DATE: 07-22-2019 (Group 1 Building Assessment was performed in December, 2018)

**UCSF building seismic ratings**

**1320 3<sup>rd</sup> Avenue – Single Family Residence**

CAAN #2005

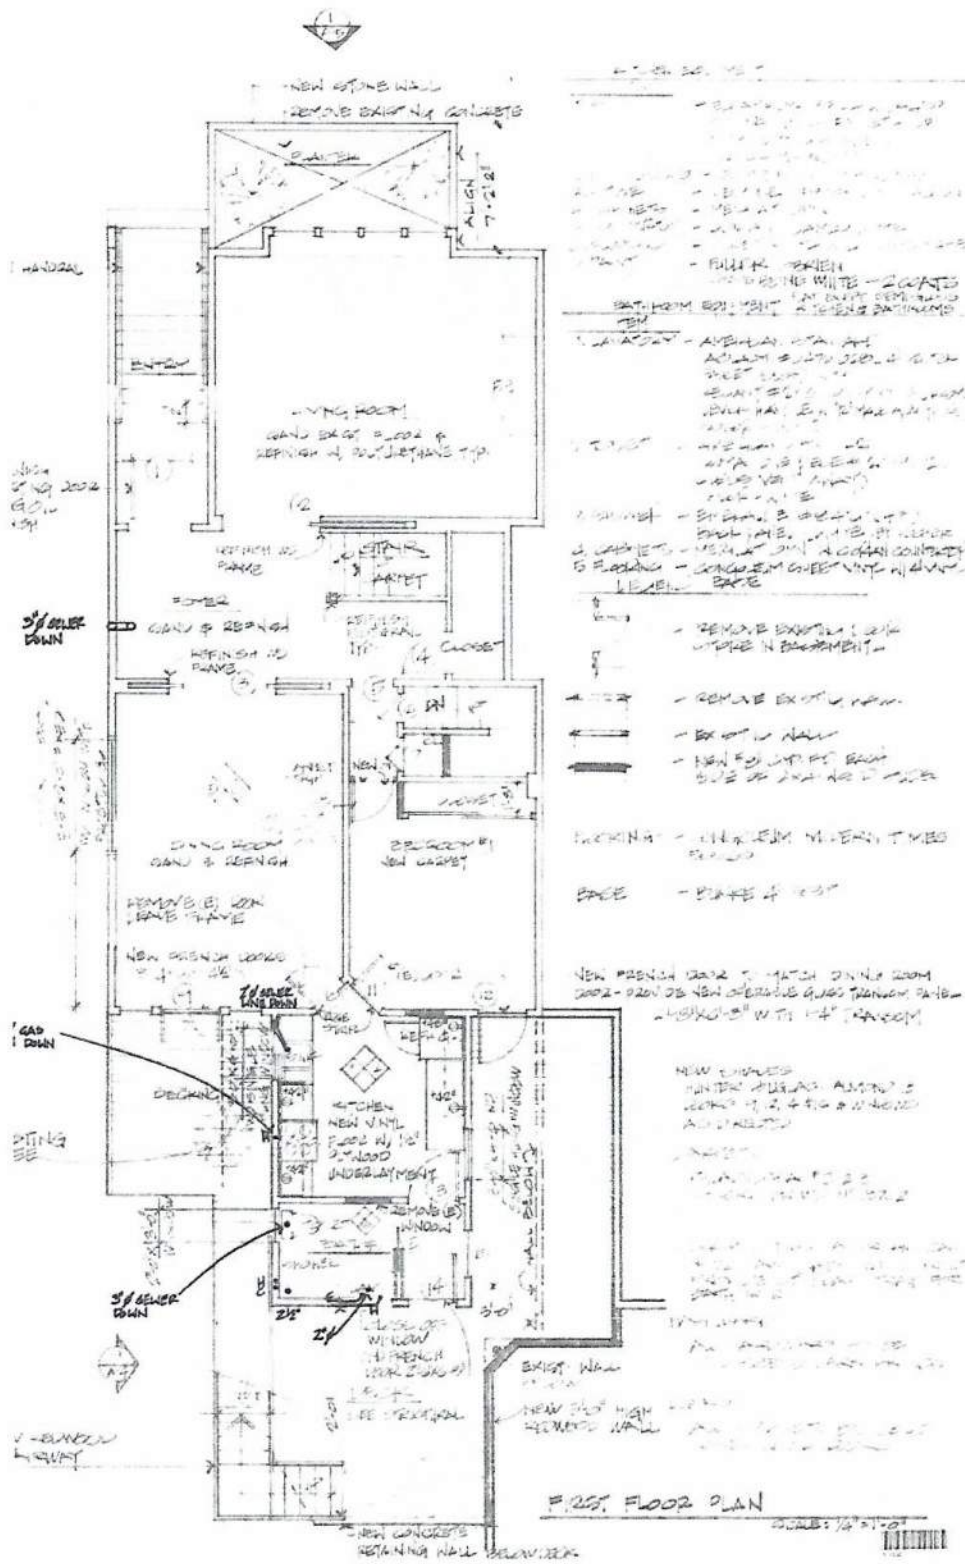
The four structural engineer members of the UCSF Seismic Review Committee (in Dec., 2018) were unanimous that the rating is on the high end of V, that the expected seismic performance will likely represent a low risk to occupant life safety, and that the building should be assigned to Priority Category B for future seismic retrofit.
